## **Summary of Submissions:**

## **NO. 109 (LOT 100) PALMERSTON STREET, PERTH RESPONSE TO SUBMISSION – FOUR (4) GROUPED DWELLINGS**

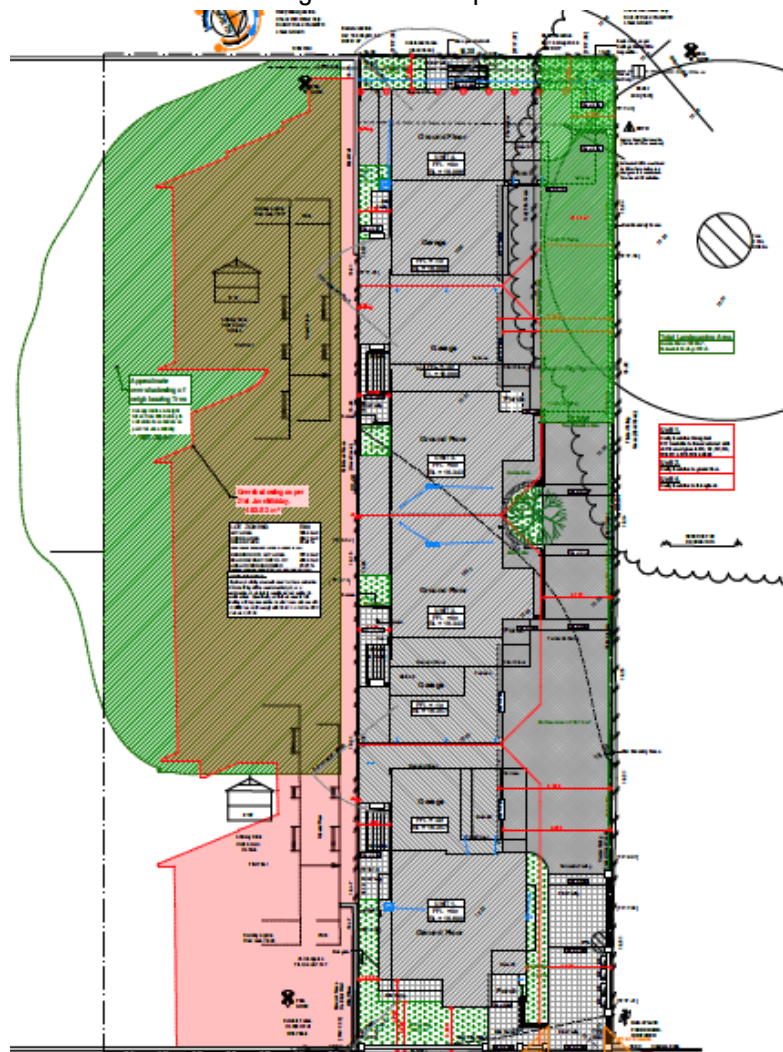
In reviewing our client's development plans, it is considered the assertions made by Planning Solutions, particularly that the proposed development does not meet the performance criteria set out in Clause 5.4.2 (i.e., designed to protect solar access for neighbouring properties), is inappropriate for the following reasons:

- The form of the proposed development is entirely acceptable on the basis that it responds to the constraints that are unique to this property discussed above.
- It is unreasonable and disproportionate to request that the design should “*protect solar access for neighbouring properties*” (Clause 5.4.2 of the R-Codes Vol. 1), when the Fig Tree causes such a significant overshadowing contribution to No. 107 Palmerston Street in its own right – refer to below image taken from the development plans which depicts the overshadowing of the Fig Tree (shaded green) compared with the overshadowing of the development on 21 June.

Notwithstanding, a closer look at the existing overshadowing situation also provides an opportunity to appropriately site a portion of the built form in the existing overshadowing pocket that occurs as a result of the Fig Tree. This is because any new buildings proposed in the existing overshadowing area will not exacerbate the winter overshadowing scenario that exists as a result of the Fig Tree.

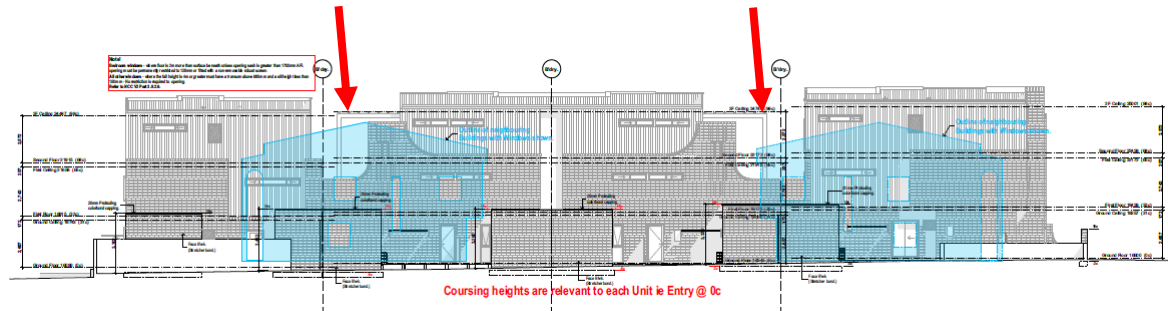
- The proposed design seeks to break-up the built form (as depicted in the development plan elevations) that were inserted to reduce the Outdoor Living Areas adjoining the properties to the south that is overshadowed by the Fig Tree during winter. Additionally, this design feature was requested by the City's Design Review Plan. The below image depicts the location of the spacing/articulation, where light and natural ventilation can be provided to the units to the south.

- The overall design also seeks to break-up the proposed built form through the use of meaningful articulations and spacing between the dwellings. This allows northern sunlight to filter through to the properties to the south at No. 107 Palmerston Street, particularly as it is clear that sunlight will be able to pass through to some of the major openings associated with the buildings to the south.
